International Organization for Migration (IOM)
The UN Migration Agency

Bid Bulletin No 3

Supply and Delivery of 10 Modular Clinics and 2 Trucks.

IFB No: 2021/MED/06/MC

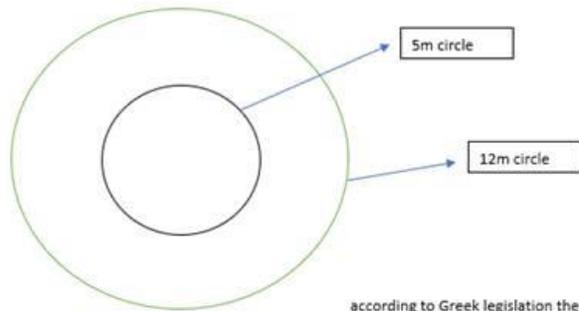
In top of page 23 you mention that Frame length shall be 15.000mm (ie 15m). According to EU and Hellenic Republic / Ministry of Transportation laws and regulations, this **cannot be achieved and type approval cannot be granted**. It needs to be re-phrased as "15m approximately or according to Greek legislation for this type of trucks"

according to Greek legislation the inner circle (5m diameter) and the outer circle 12m diameter the towable trailer shall be moving within the threshold. A 15m length will not get approval except if IOM will issue a relevant particular Ministerial decision.

The max regular (within law limits) type approval max dimensions shall have

The trailer should be approximately 13,6 m and under no circumstances the trailer with the truck should not be exceeded the specifications defined by the current legislation.
